Development of Customized Local Road Vehicle (CLRV) Standards

Jeepney/Multicab Manufacturer's Assembly Line

**Observations
and
Recommended Process
Flow**

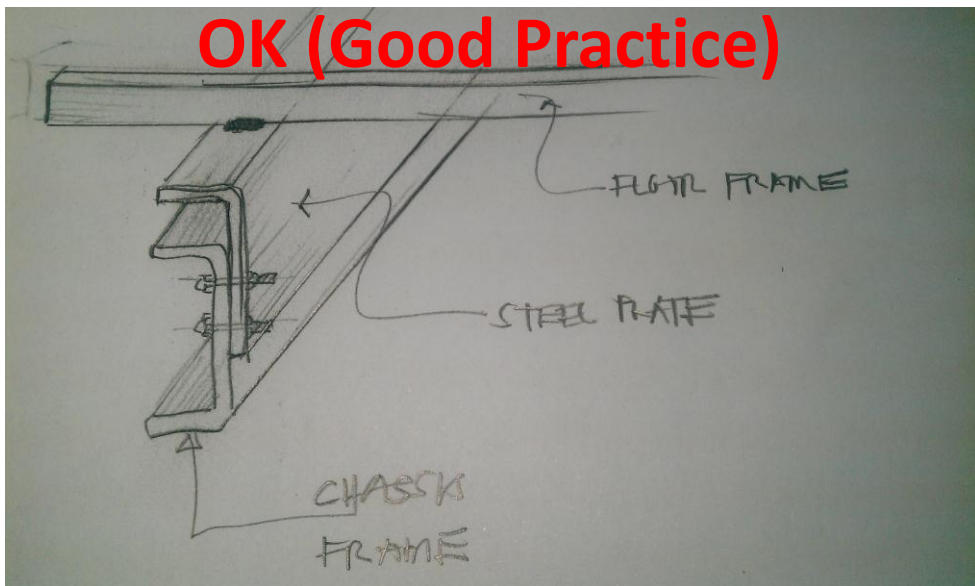
Don't exceed the allowable front and rear overhang and wheelbase

Extending the chassis length is not a safe practice. Use appropriate size

Don't fabricate your own chassis frame

Don't overweight your body structures (it will make the vehicle fuel inefficient and become costly)
